Re: Request for Access to Information under Part II of the Access to Information and Protection Privacy Act (the ATIPP Act, 2015)

All building files regarding 47 Harvey Road.

Re: **File #96-00488 (B-17-L.13)**
Proposed Mixed Use Building (2 Dwelling Units & Architectural Practice)
Civic #50-52 Long's Hill

Re: **50-52 Long's Hill**
2 Dwellings & Home Occupation
File # B-1-97-0021

ONE FLOOR BELOW MEZZANINE @ 11:00

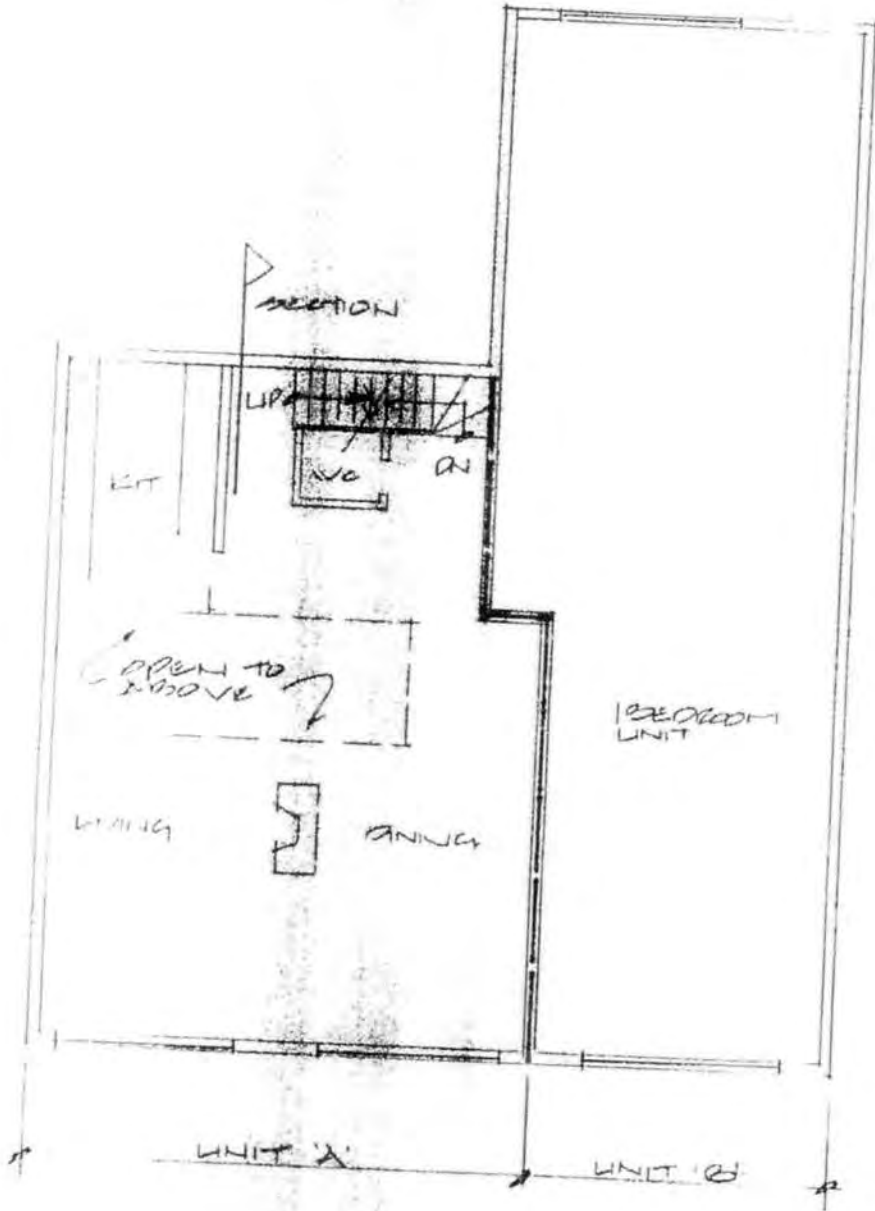
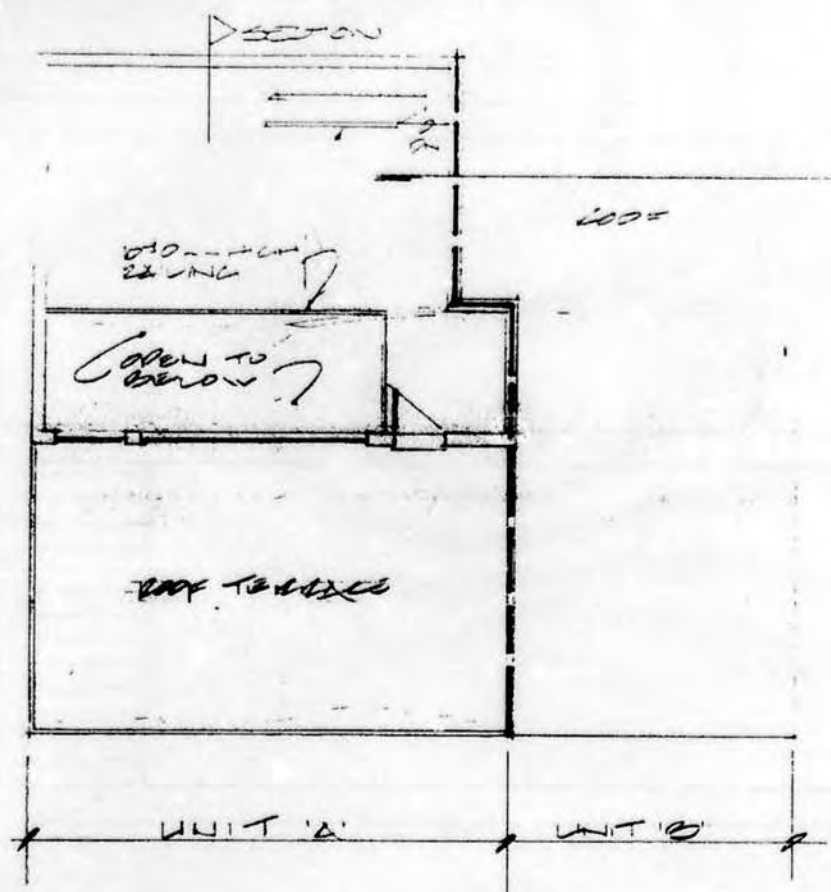
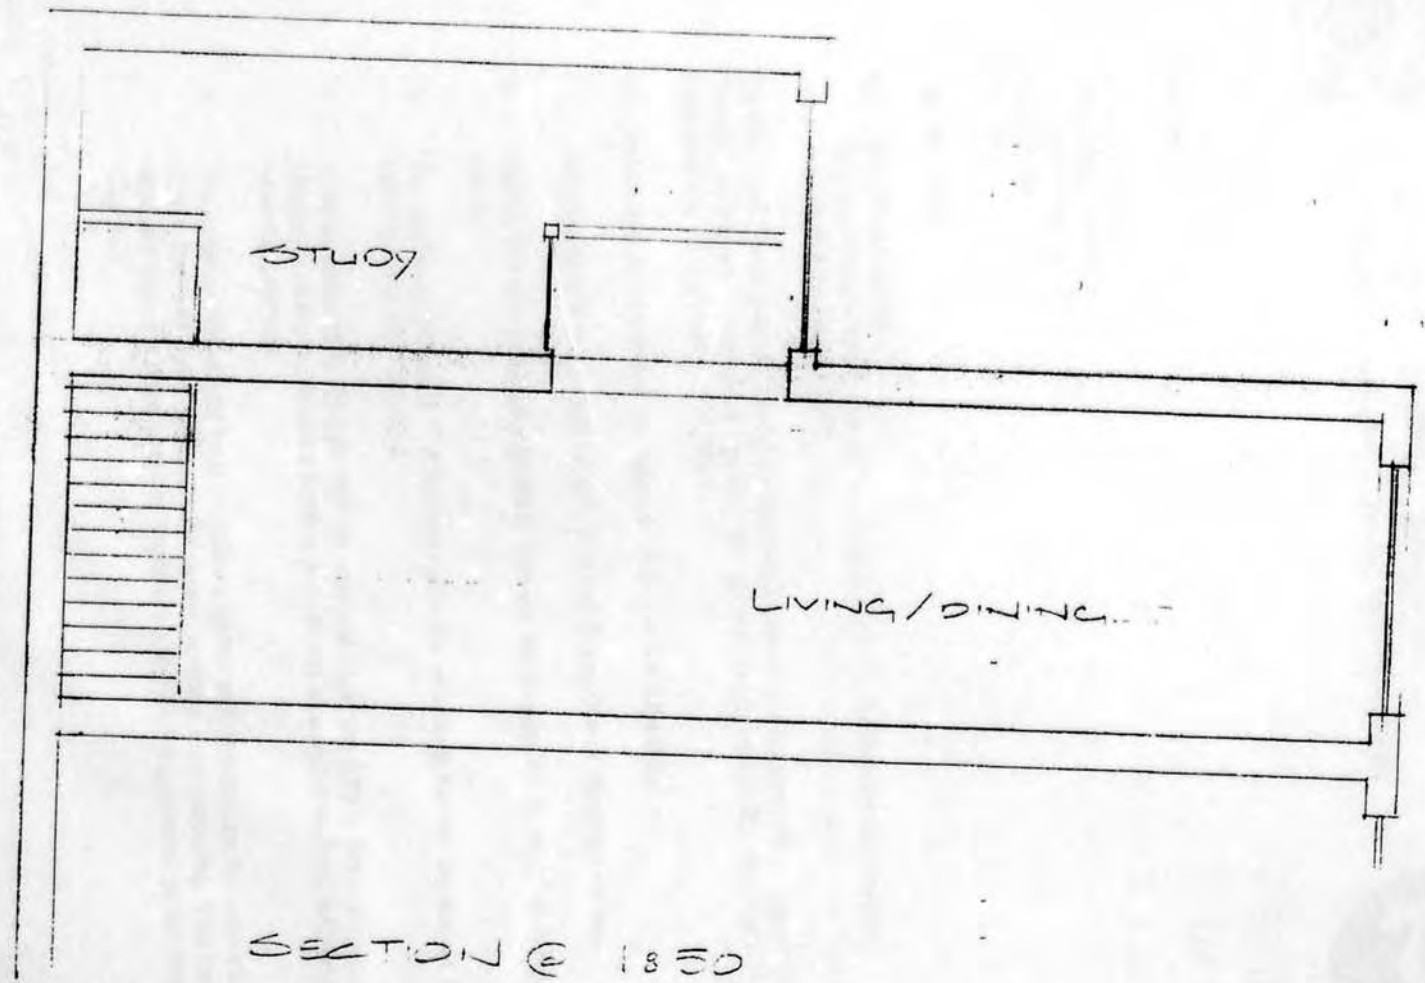
As we discussed yesterday afternoon, would you please review these diagrams and let me know if I am correct in assuming that the mezzanine floor would not be calculated in determining building height. I am interpreting parts 3.2.1.1.(3) and/or 9.10.4.1(1),(2) of the 1995 National Building Code of Canada.

If I am incorrect in my assumptions, please call me so I may re-design to make this work.

If I properly understand the sketches that you FAXed to me, the area designated "Study" is indeed a mezzanine and need not be considered a storey according to Sentence 9.10.4.1.(2) of the 1995 NBC since it is less than 40% of the floor area of the storey below and it is visually open to the storey below.

PROPANE TANK LOCATION

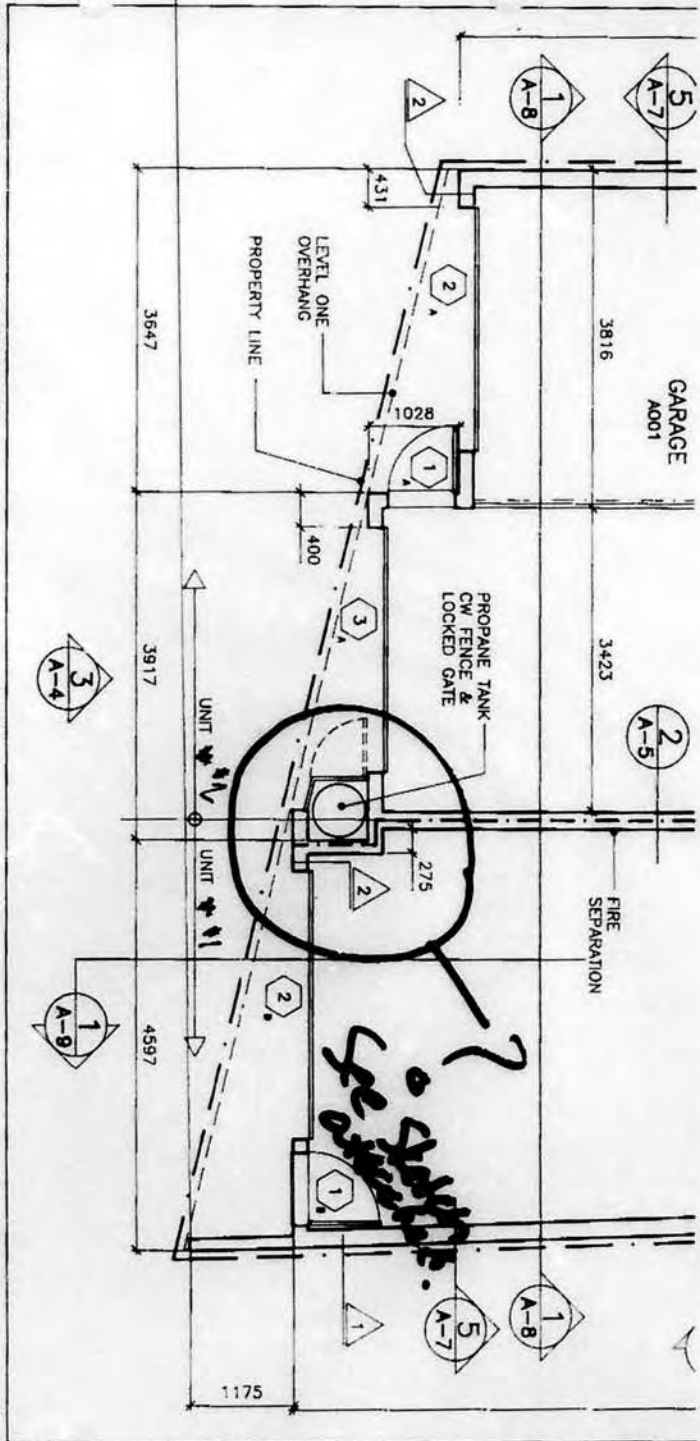
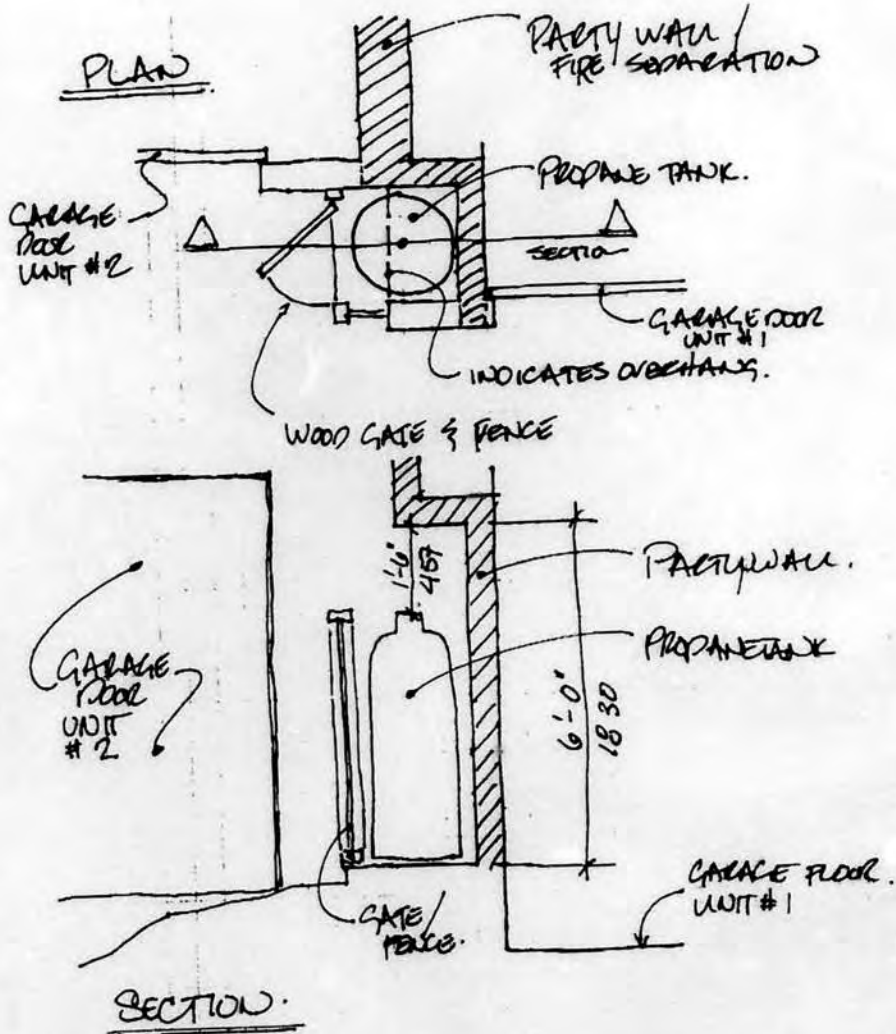
Could you please review the attached sketches for the proposed location of a propane vent (to serve a fire place in unit # 2). Will this arrangement be acceptable. The contractor, is, of course on site, waiting for an answer from me.

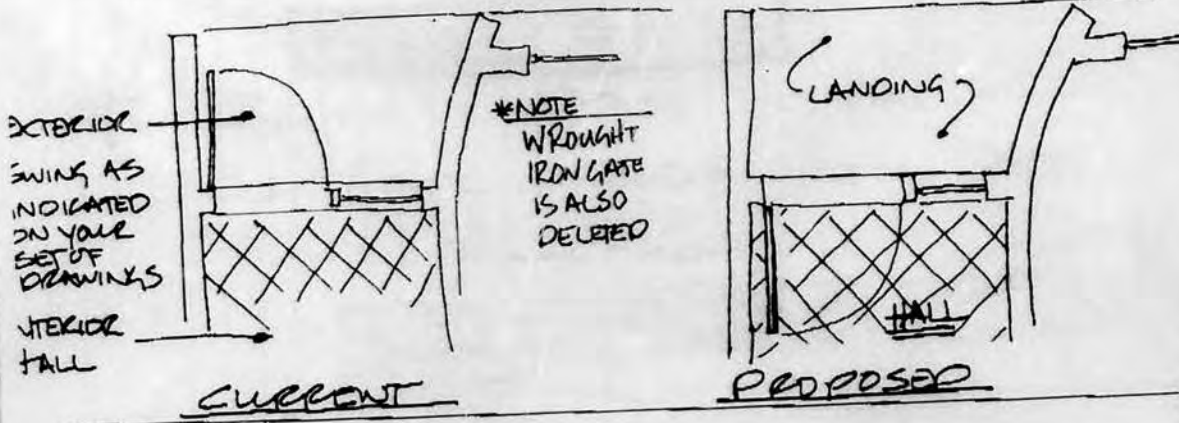
I would like to change the direction of door swing for the main exterior entry door at the Harvey Road sidewalk, from an out-swing to an in-swing. Will this be acceptable? If not I shall keep it as the drawing currently shows it which is ~~outswing~~ **outsings**.

project 47 Harvey Rd. title Door Elevation Entry to Unit B'

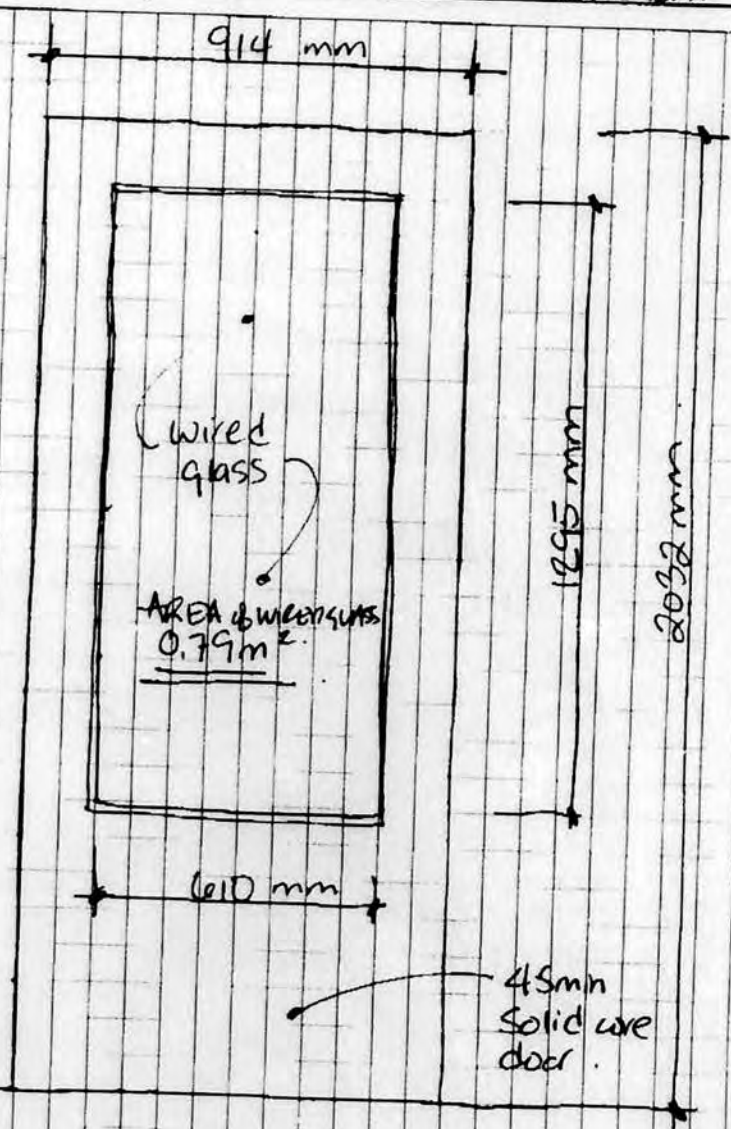
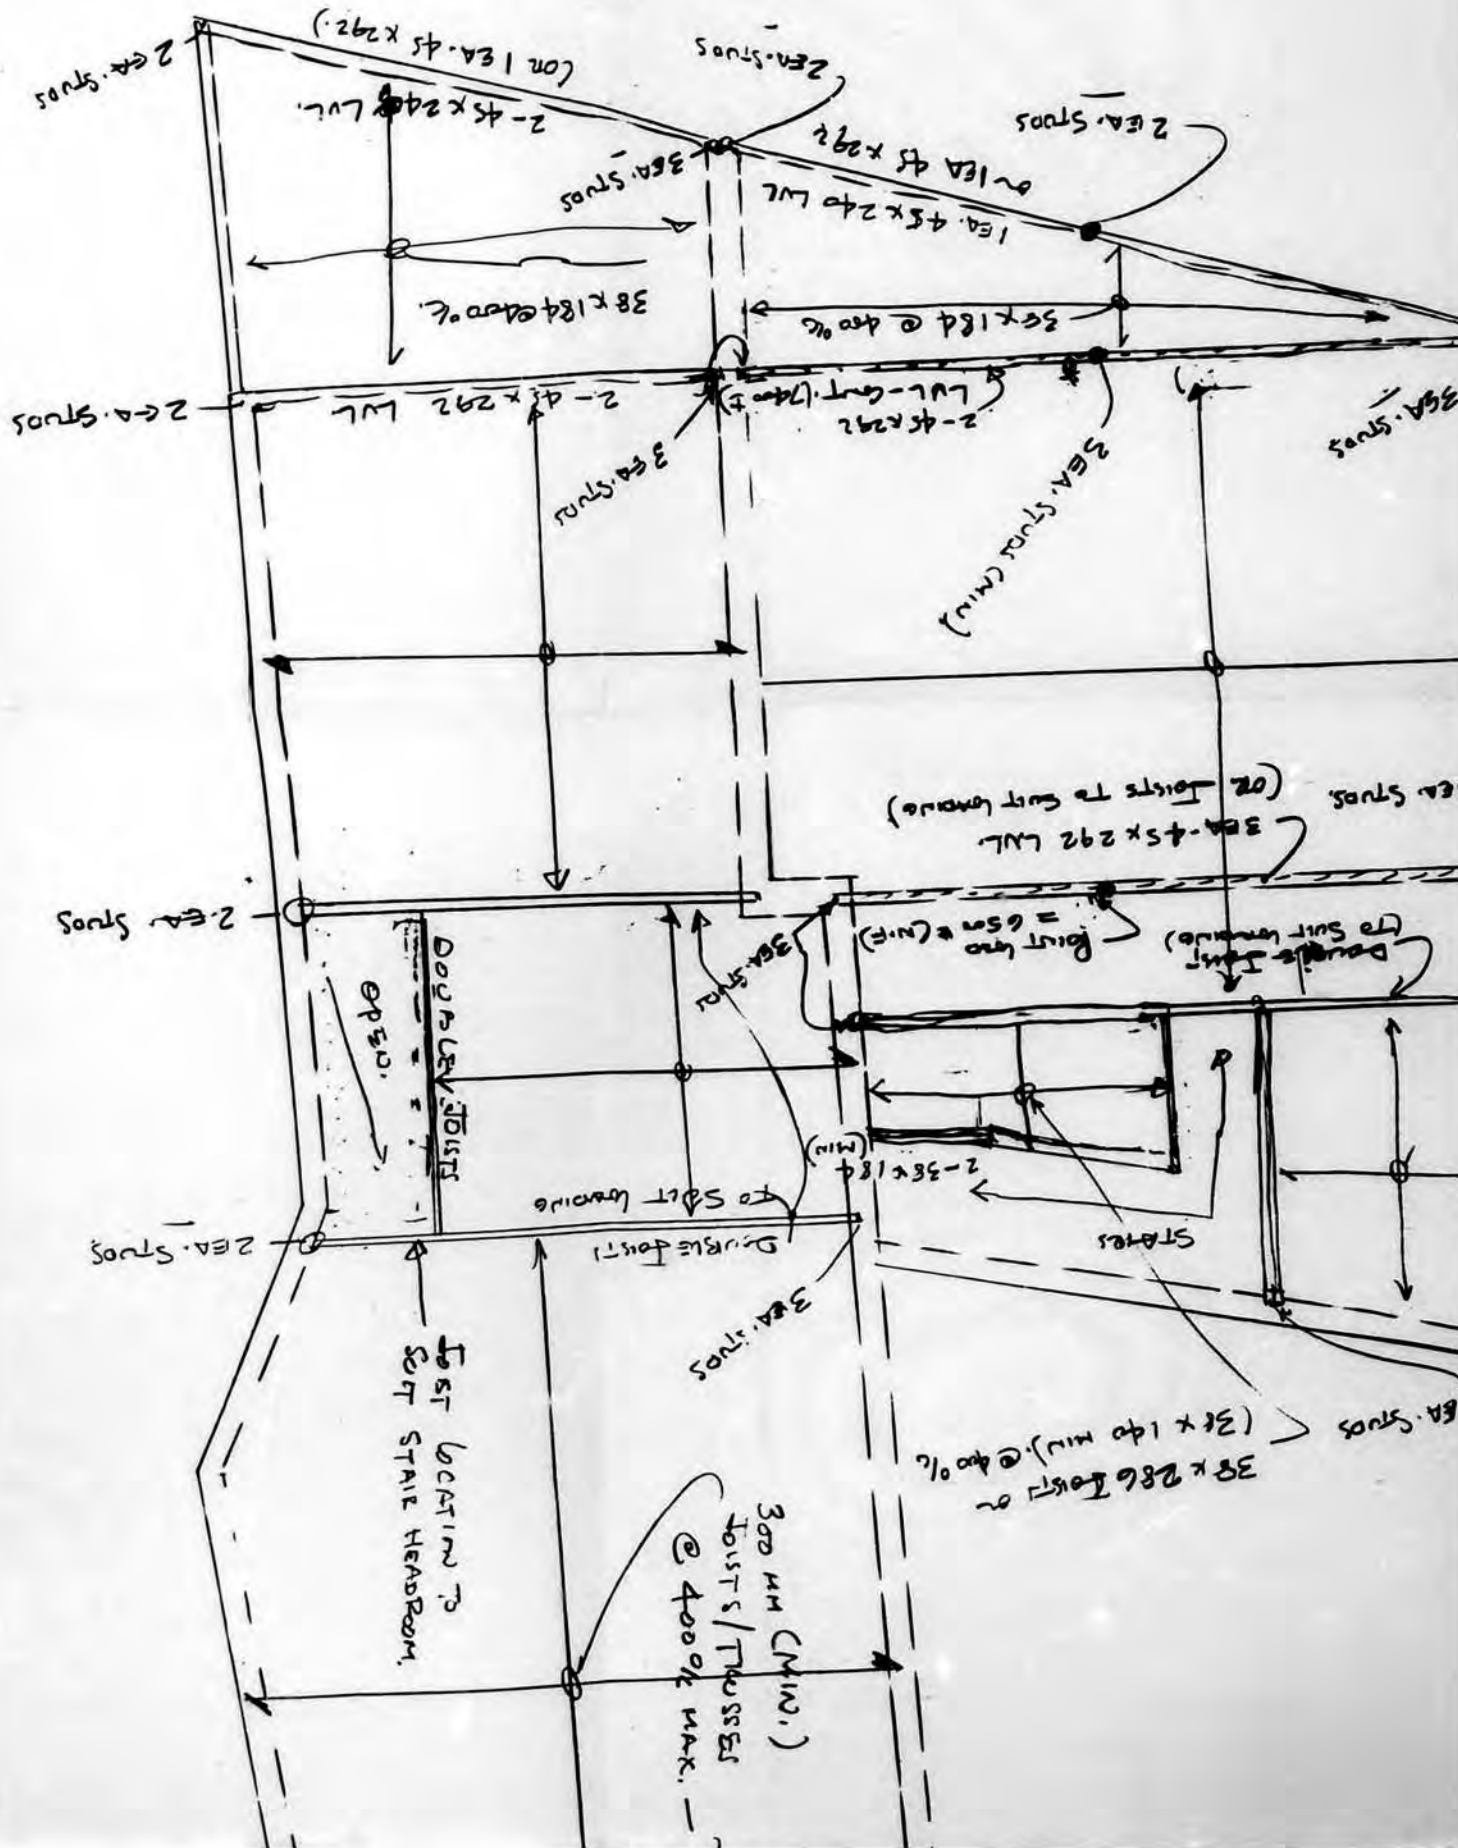
In response to Rod Parsons conversation with you about the dwelling unit entry doors @ the common corridor:

Section 9.10.9.15 requires a 45 min fire separation between public corridors & the remainder of a building. I would think that this would apply to this situation: please see attached sketch for wall & door frame detail:

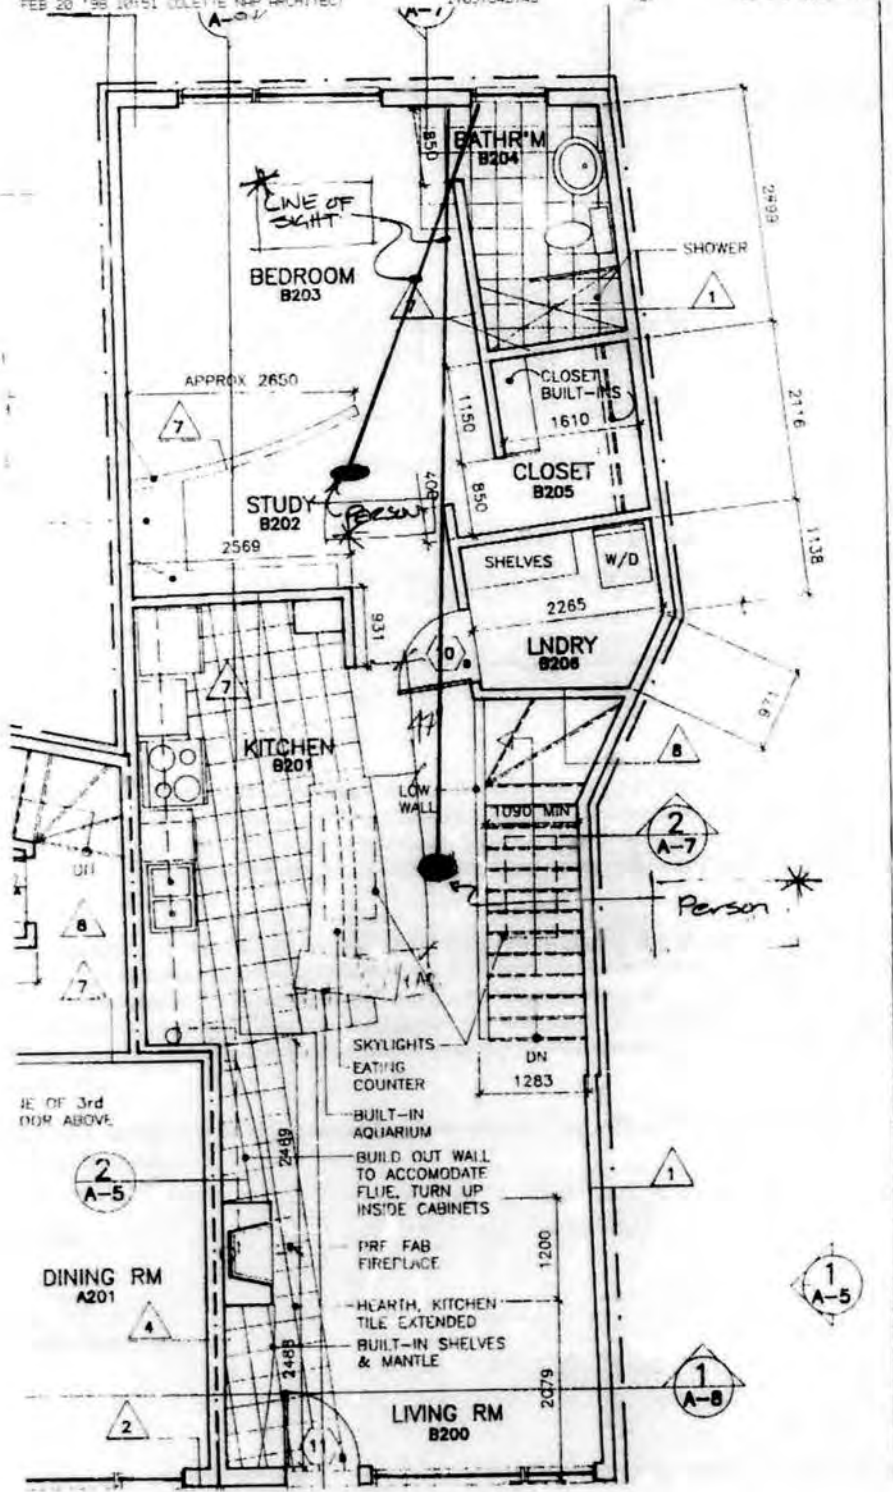
Pursuant to our conversation yesterday evening concerning the Master Bedroom Ensuite, which has no door, I would like to state my case:

- ✓ Firstly, this bathroom is part of the master bedroom, thus private from guests.
- ✓ Secondly, there is a washroom for guests to use on the main floor.
- ✓ Thirdly, the attached sketch illustrates that it is not possible to see into the ensuite from any point in the living spaces.
- ✓ Fourthly, it is my understanding that the National Building Code deals with..."regulations for public health, fire safety and structural sufficiency..." and although it states that "A door shall be provided...to each room containing a water closet within a dwelling unit", I fail to see how an ensuite without a door threatens any of these regulations.

I shall certainly assume full professional responsibility if this design feature was to bring harm to another person. It is not my intention to cause trouble, but for myself, a person living alone, is it really necessary to have a door on your ensuite? I hope this is acceptable to you. I look forward to hearing from you. Thank-you.
